Access Compliance Report

Public Rights-of-Way

(Curb Ramps)

Intersection ID: 17250	Main Street: CROYDON_RD	Cross Street: QUEENS_RD_WEST	Location: SE
ADA ID: 8B82ACBF2A9B	Ramp Type: Perp	Initial Pass/Fail: Fail	Overall Compliance: No
Severity Score: 1.25			
Codes/Mitigation Info/Possible Solution		Field Measurements/Component Compliance

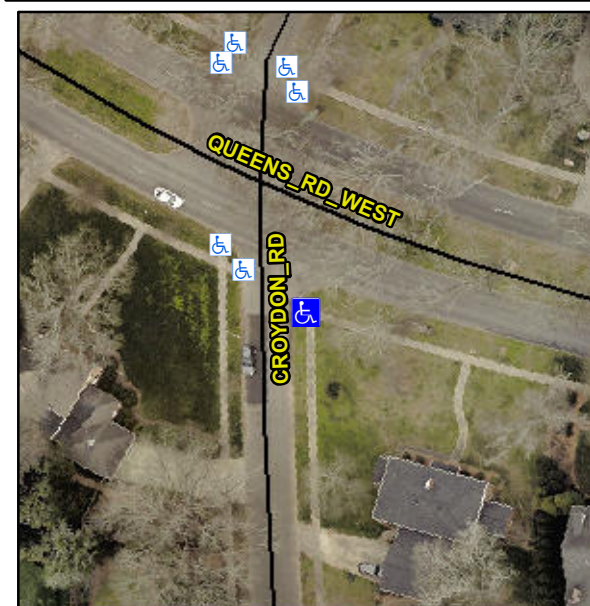
R304.5.3

Compliance	Description	Data	Compliance	Description	Data
N/A	Ramp Length (in)	116.0	Yes	Ramp Slope (%)	7.2
Yes	Ramp Width (in)	48.0	No	Ramp XSlope (%)	2.2
N/A	Flare Type LT	N/A	N/A	Flare Type RT	N/A
N/A	Flare Slope LT (%)	N/A	N/A	Flare Slope RT (%)	N/A
N/A	Flare Traversable LT?	N/A	N/A	Flare Traversable RT?	N/A
N/A	Landing Length (in)	N/A	N/A	DWS Provided?	N/A
N/A	Landing Width (in)	N/A	N/A	DWS Contrast?	N/A
N/A	Landing Slope (%)	N/A	N/A	DWS Length (in)	N/A
N/A	Landing X Slope (%)	N/A	N/A	DWS Full Width?	N/A
N/A	Landing Curb? (Y/N)	N/A	N/A	DWS Offset (in)	N/A
N/A	Shared Landing?	N/A			
N/A	Gutter Ponding?	Yes	N/A	Gutter Slope (%)	N/A
N/A	Gutter Lip Ht (in)	N/A	N/A	Gutter X Slope (%)	N/A
N/A	Painted X Walk1?	No	N/A	Painted X Walk2?	N/A
	X Walk 1 Direction	To NW		X Walk 2 Direction	N/A
N/A	X Walk 1 Width (in)	N/A	N/A	X Walk 2 Width (in)	N/A
	X Walk 1 Slope (%)	0.1		X Walk 2 Slope (%)	N/A
	X Walk 1 X Slope (%)	0.3		X Walk 2 X Slope (%)	N/A

Remove & Replace Entire Ramp.
